Permit No. 01281 Issued 11-19-86 date
 Job Location 653 W. Clinton address
 Lot 34 Sheffields 2nd Add. sub-div or legal discript
 Issued By Eldon Huber building official
 Owner Robert Behrman 592-8283 tel.
 Address R.R. 2 Napoleon, Ohio
 Agent Robert Behrman 592-8283 tel.
 Address R.R. 2 Napoleon, Ohio
 Description of Use Residence
 Residential 1 no. dwelling units
 Commercial Industrial
 New Add'n X Alter X Remodel
 Mixed Occupancy _____
 Change of Occupancy _____
 Estimated Cost \$ 4,000.00

RESIDENTIAL PLAN CORRECTION SHEET

Permit No. 01281
Owner ROBERT BEHRMAN
Contractor ROBERT BEHRMAN
Location 653 W. LINDSDALE

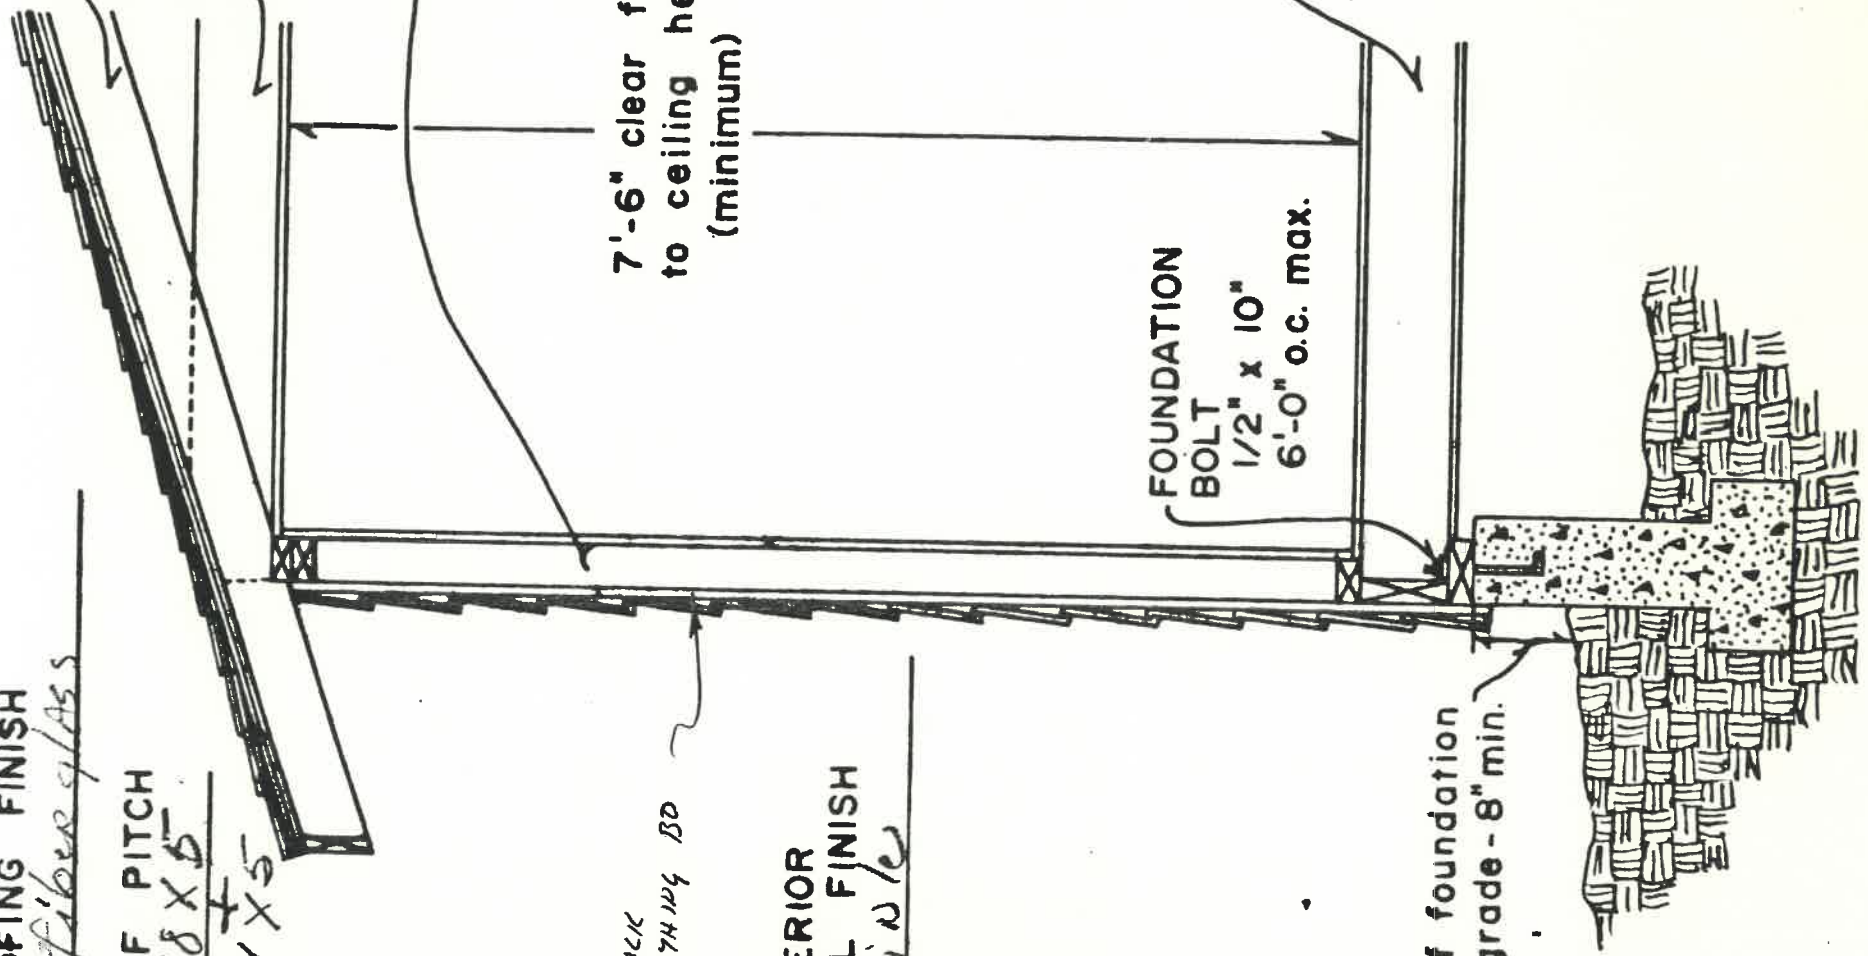
GENERAL	
<input checked="" type="checkbox"/> Provide approved smoke detector(s) as req'd.	Show size of members supporting porch roof.
<input checked="" type="checkbox"/> Provide 1/2" gypsum wallboard between dwelling and garage, on garage side.	Provide double top plate for all bearing partitions and exterior walls.
<input checked="" type="checkbox"/> Provide min. 1 3/8" solid wood door from garage to dwelling. (or equal)	Provide design data for prefab wood truss.
Submit fully dimensioned plot plan.	Ceiling joists undersized in
Provide min. of 1-3'0" x 6'8" exit door.	Roof rafters undersized in
Provide min. 22" x 30" attic access opening.	PLUMBING AND MECHANICAL
Provide min. 18" x 24" crawl space access opening.	<input checked="" type="checkbox"/> Terminate all exhaust systems to outside air.
<input checked="" type="checkbox"/> Provide approved sheathing or flashing behind masonry veneer.	<input checked="" type="checkbox"/> Insulate ducts in unheated areas.

<input checked="" type="checkbox"/> Foundation. HVAC rough-in.
Show size of wood girder in	Plumbing rough-in. <input checked="" type="checkbox"/> Final Building
Provide design data for structural member in	Plumbing final. other,
Floor joists undersized in	Electrical service.
Provide double joists under parallel bearing partitions.	Electrical rough-in.
Provide 1" x 4" let in corner bracing, approved sheathing, or equal.	Electrical final
Show size of headers for openings over 4' wide

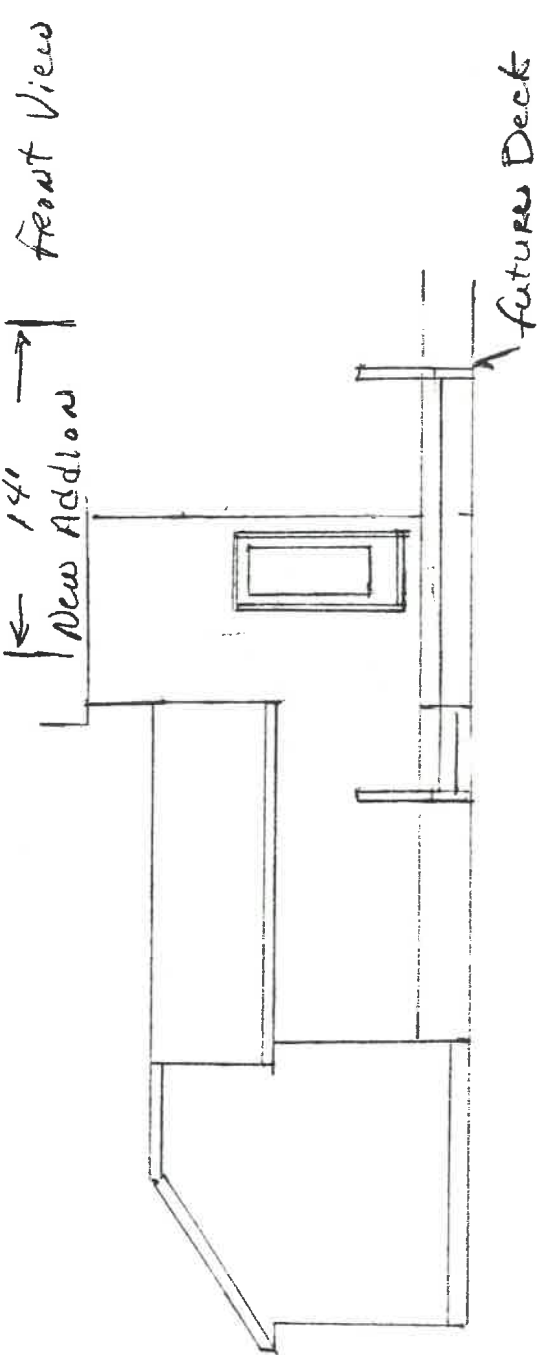
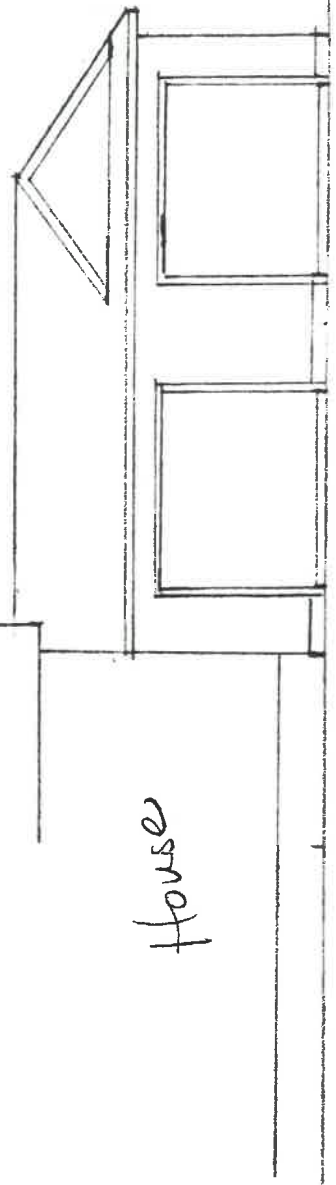
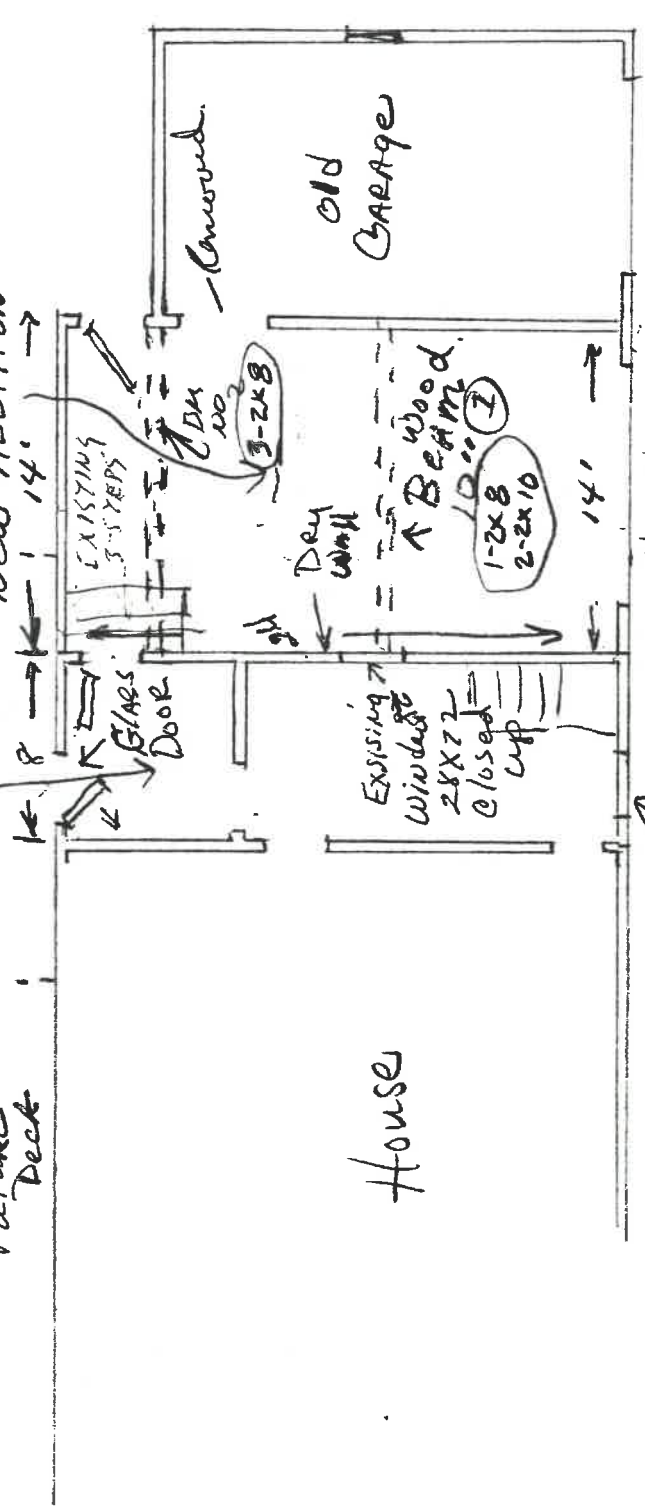
ALSO THE ELIMINATION OF A PARKING
SPACE REQUIRES A NEW ONE IF
THE MAKE THE GARAGE 1070 A FARM RM

SHOW STAIRWAY BETWEEN GARAGE &
PORCH

DESIGN BEAM AND HEADER

LOCATE WOOD BEAM SUPPORTING ROOF

PROVIDE TREATED PLATE AT BASE OF
WALLS OR PLATE TO BE LOCATED
8" ABOVE GRADE

BEAMS UNDERDESIGNED
DOOR HEADR UNDERDESIGNED

SHOW STEPS AND LANDING AT
GARAGE SIGN OF PORCH DOOR

MAX. HT. FROM PORCH FLOOR LINE
TO DECK IS 8 1/2"

MAX STAIR RISE HEIGHT IS 8 1/4"
ALL RISERS SHALL BE THE SAME
